**RFP Title: Site Improvements at Roger Williams Park Event Pavilion**

**Addendum #: 1**

**Issue Date: 01/23/2024**

The purpose of this addendum is to extend the bid opening and answer questions from the Pre-Bid meeting.

# LIGHTING PLAN

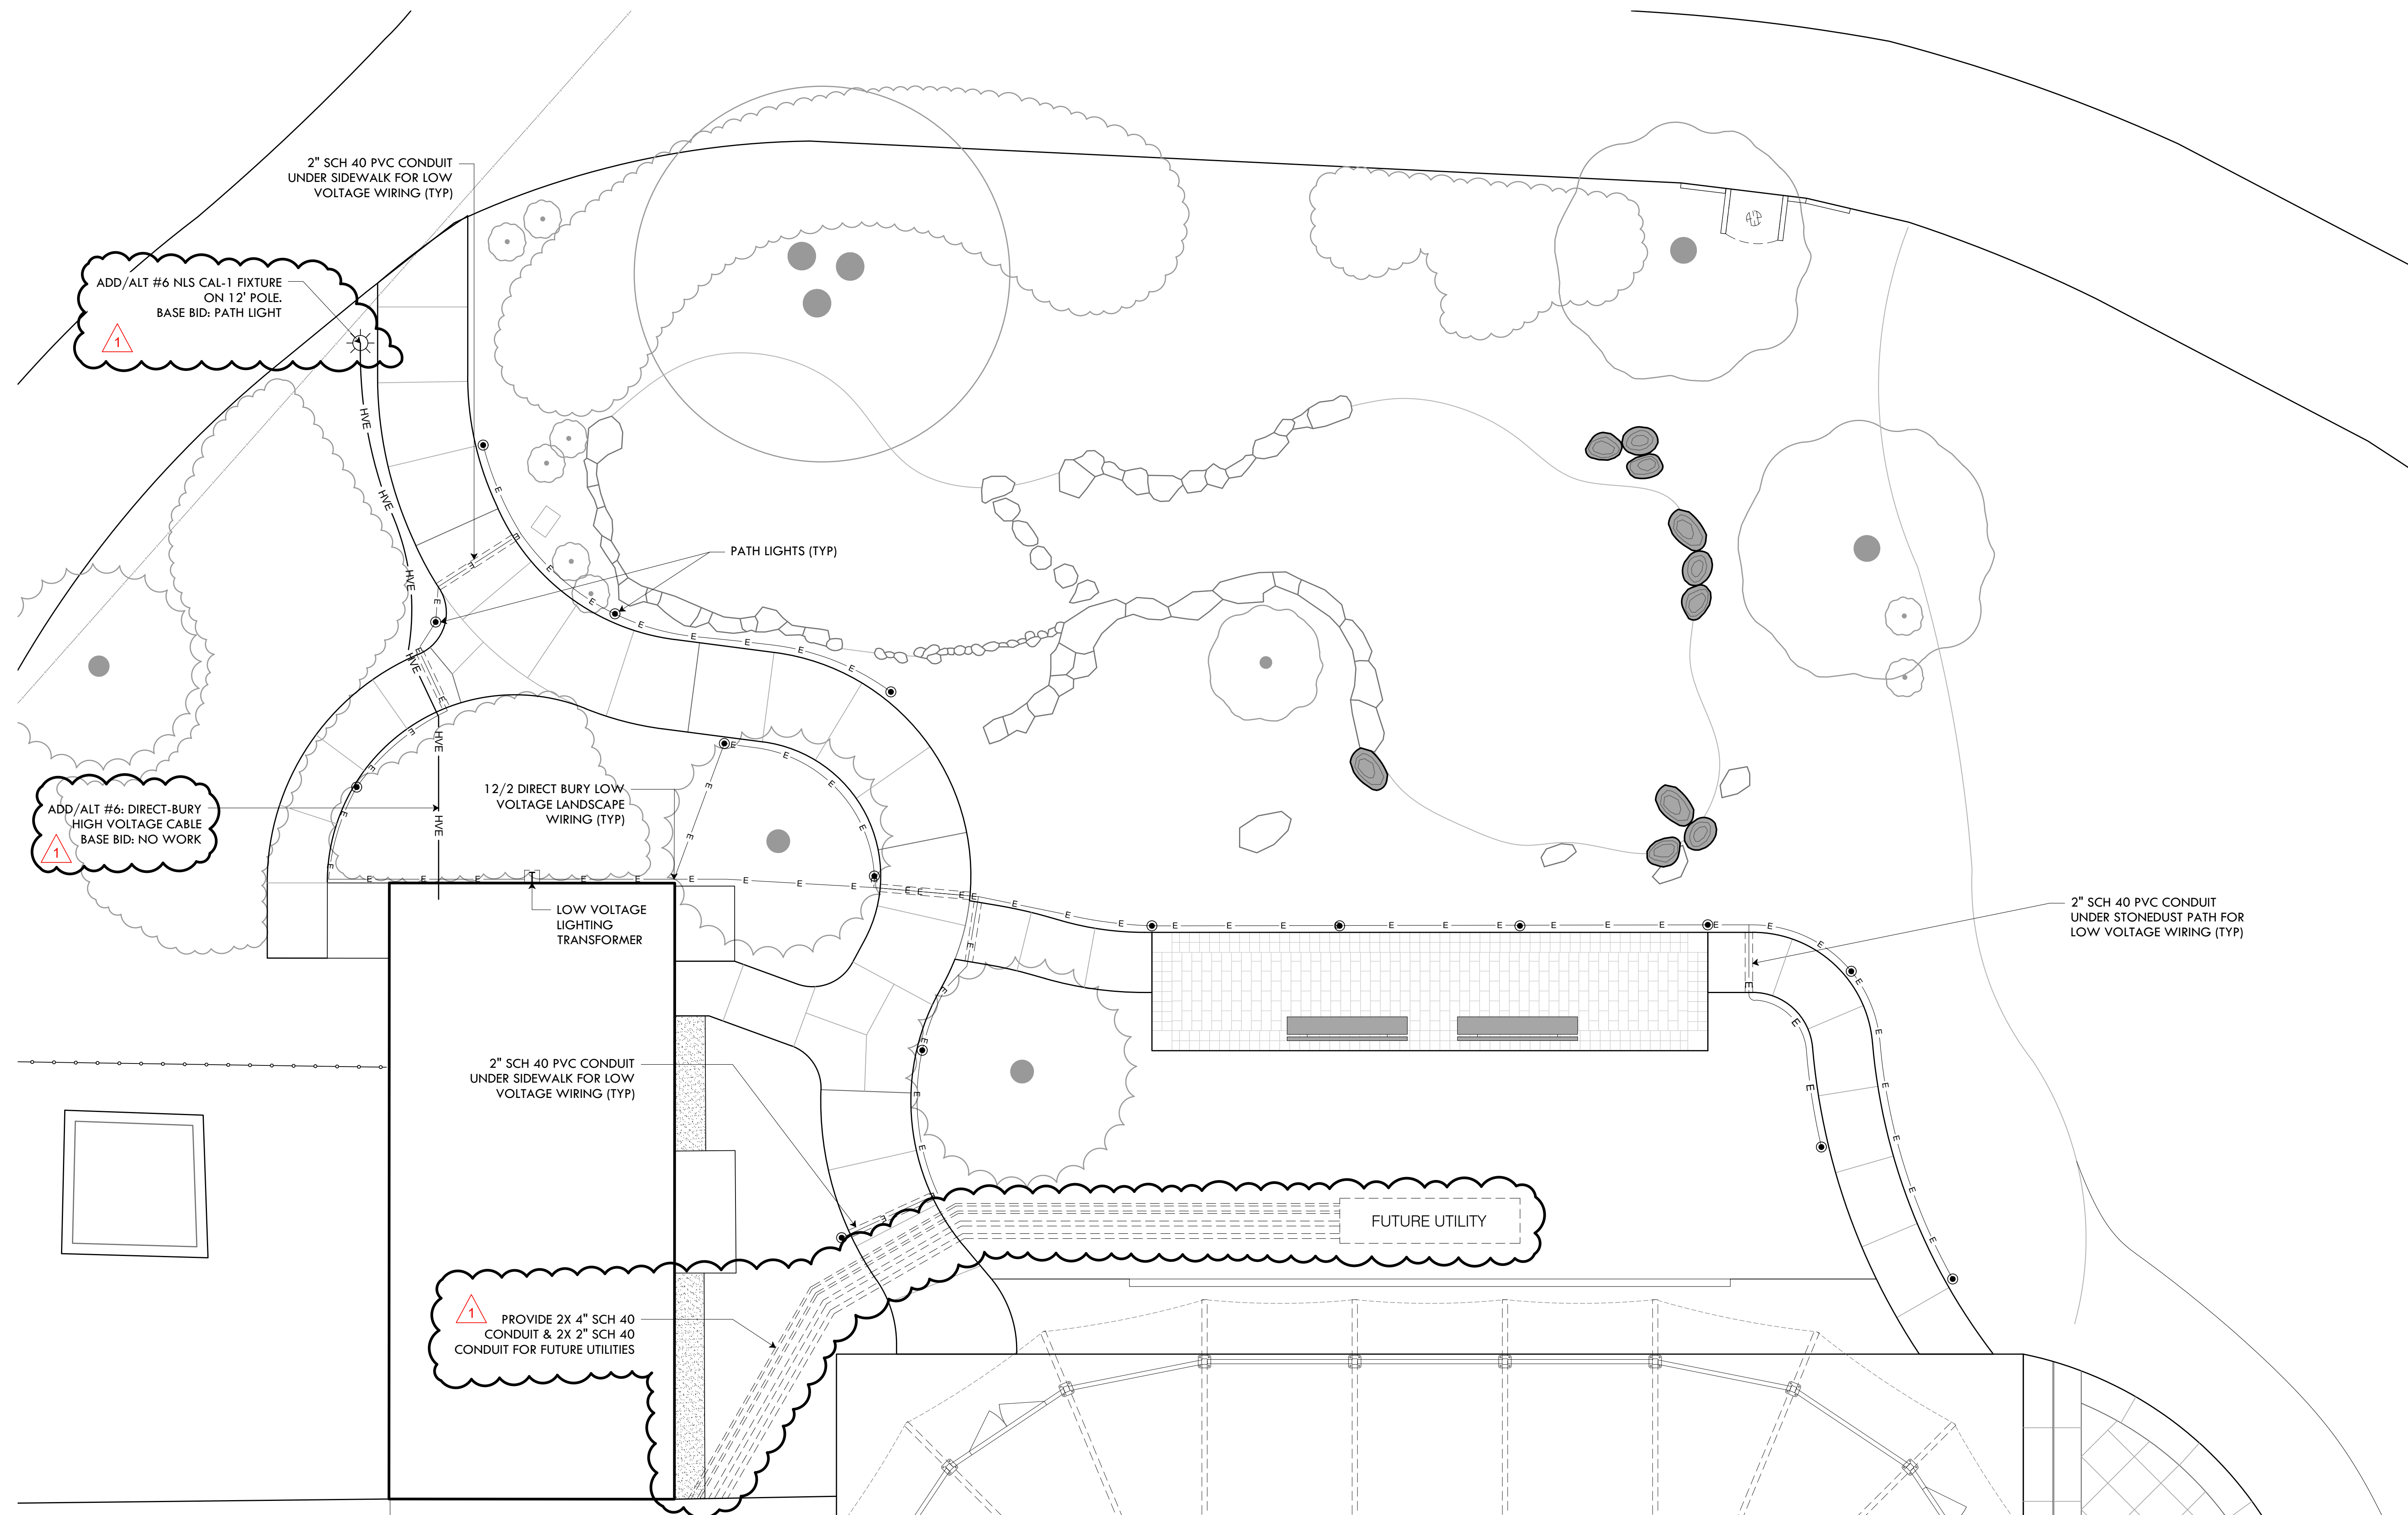
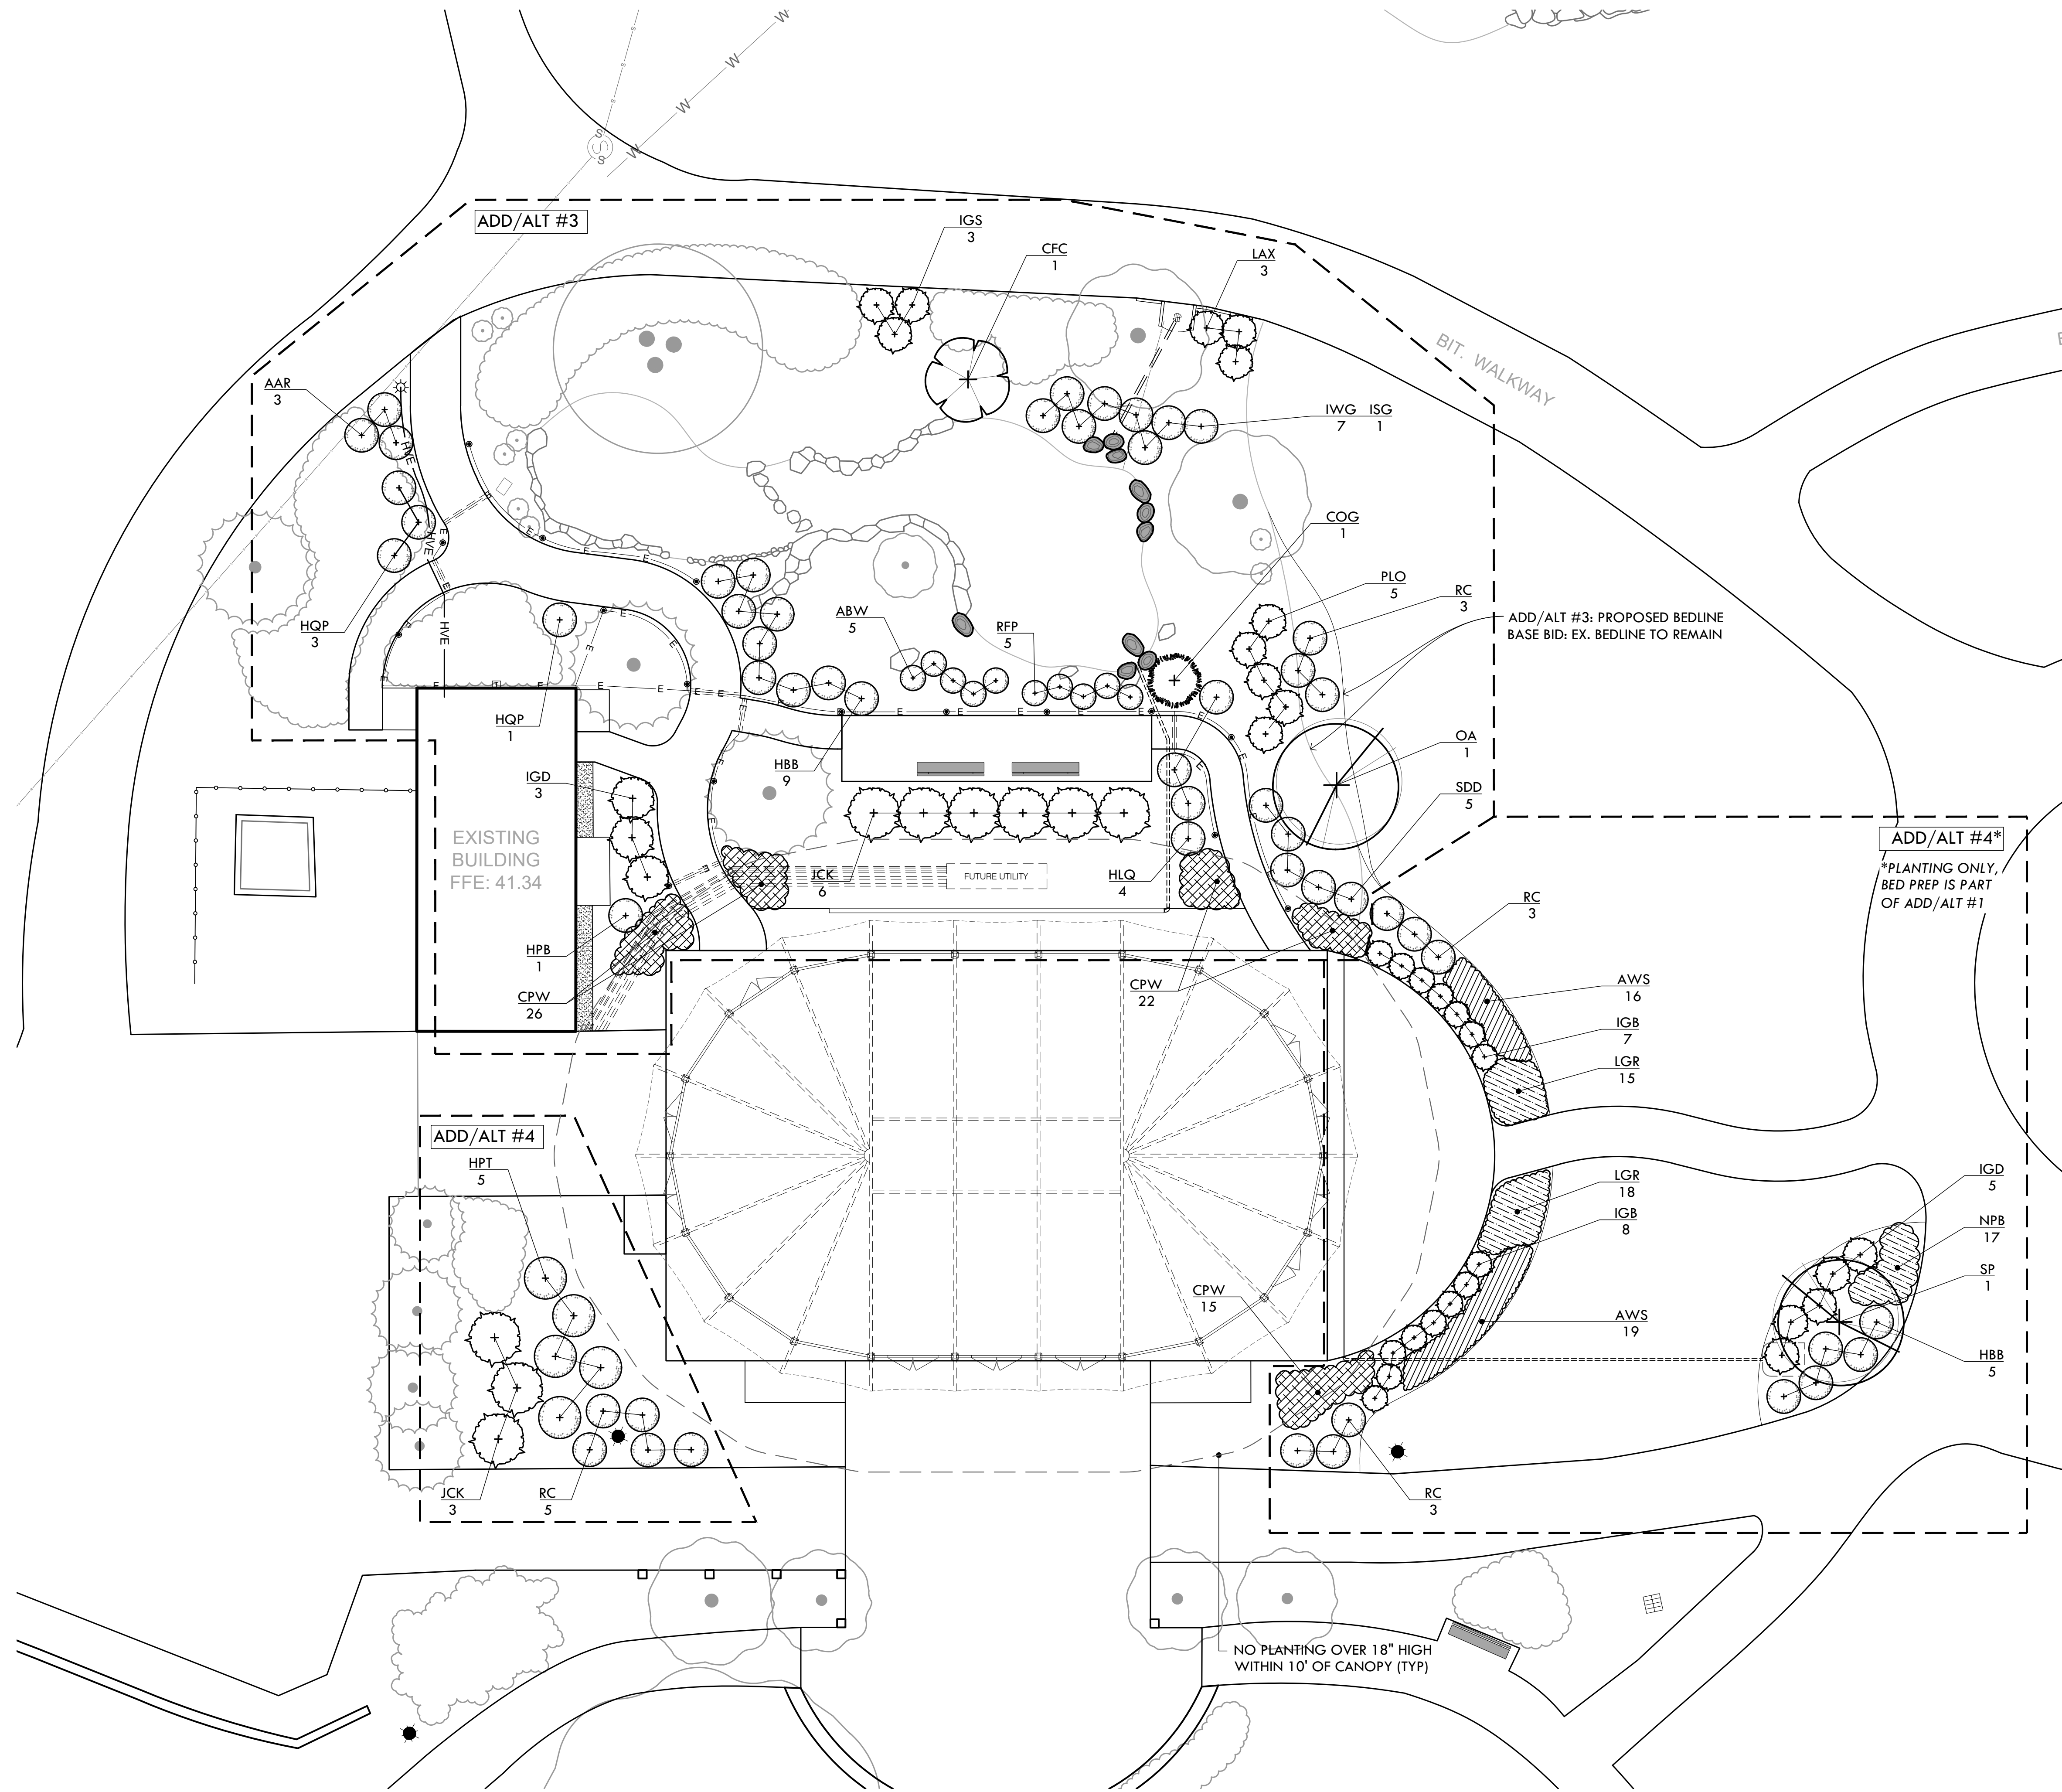
3. *Q: The spec states the fixtures must be dimmable, but the light fixtures specified do not have that capability, nor do the transformers produced by that manufacturer. We recommend FX Luminaire or Kichler (who have an identical fixture) to fulfill the dimming requirements.*

4. *Q: Type and size of transformer required/ Are there existing controls for the new fixtures or do new controls need to be provided?*

**A: Dimming is not required. See updated lighting plan for transformer.**

**A: Please see updated lighting plan for transformer**

**5 RIVERSTONE DRIPLINE W/ STEEL EDGE**  
NTS

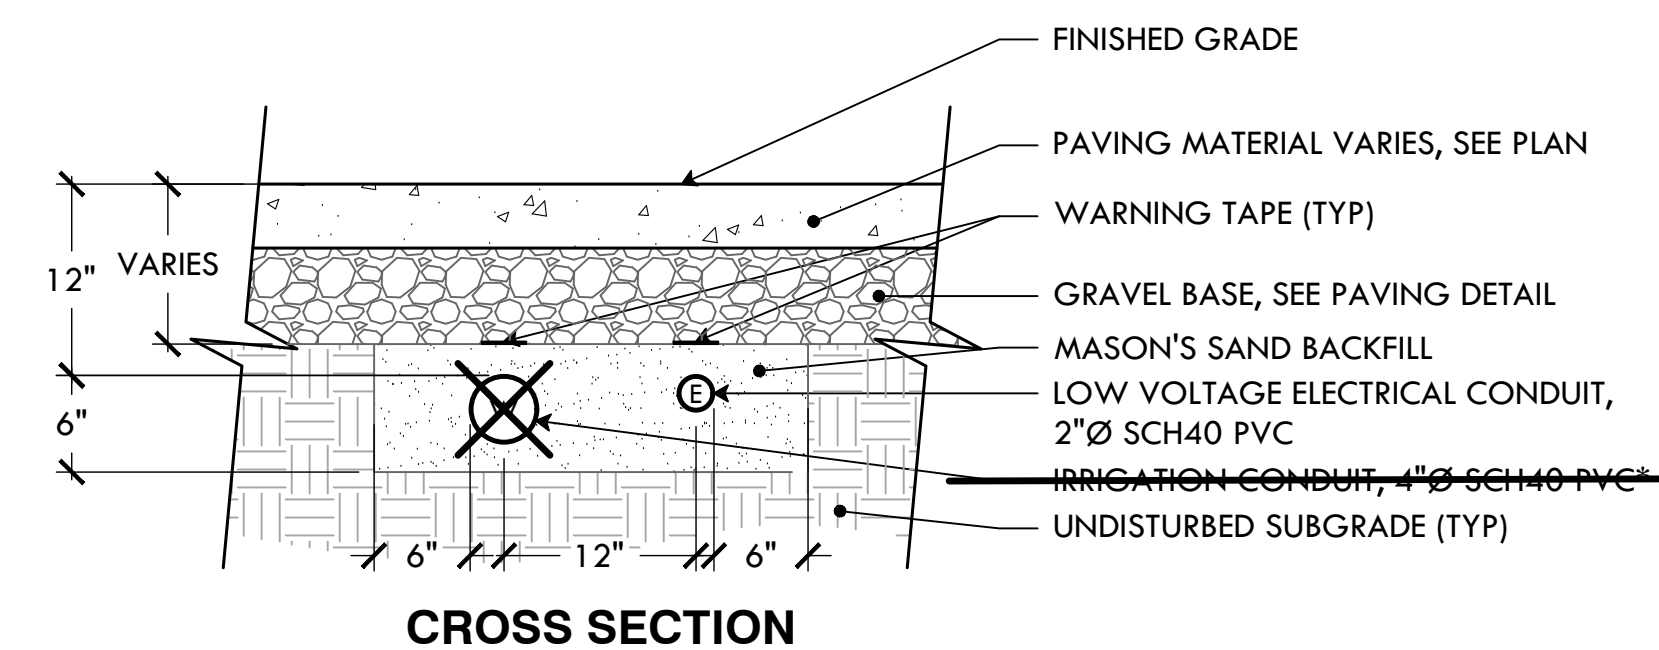
9. *Q: On sheet L6, where the pre-sloped drain is located, it appears to be riverstone with steel edging (detail 5 on L7). However, is not called out. That is just called out behind the pavilion but it appears to be the same hatch.*

**A: Yes, this area is riverstone with steel edging, however, there would be no edging against the drain, it would butt into the sides, see adjusted detail.**

**6 LOW-VOLTAGE LIGHTING CONDUIT**  
NTS

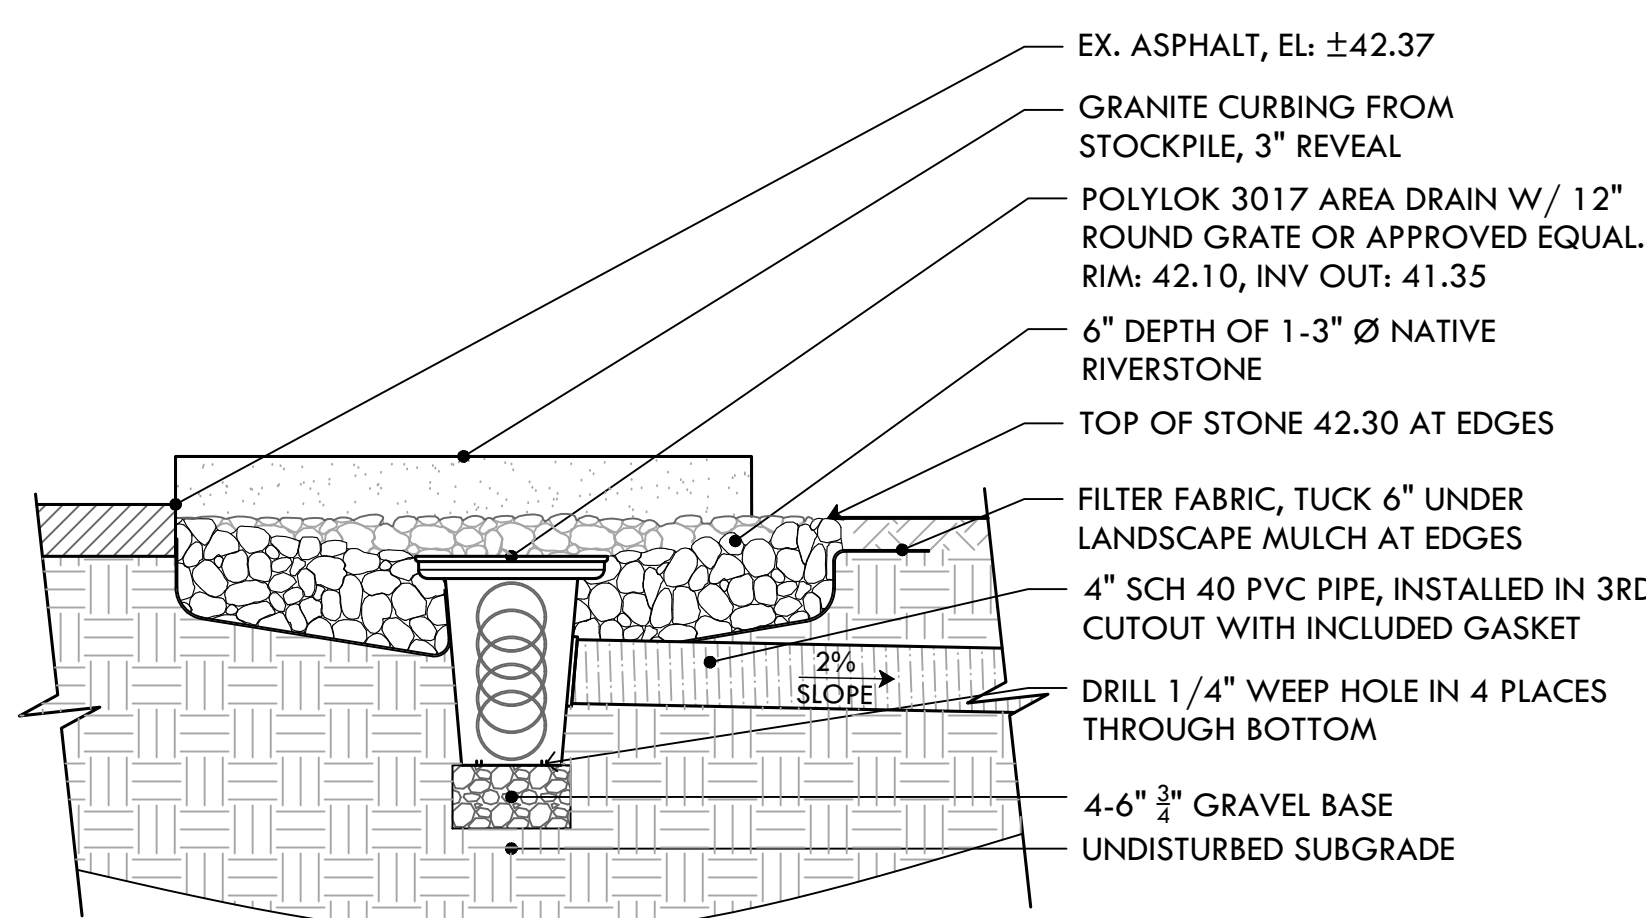
6. *Q: Plan L-7 detail 6 shows an irrigation sleeve. Are we to assume that this is planning for a future irrigation system because there is no mention of an irrigation system on the plans/specs?*

**A: Irrigation Sleeve not required, see updated detail in the plans attached**
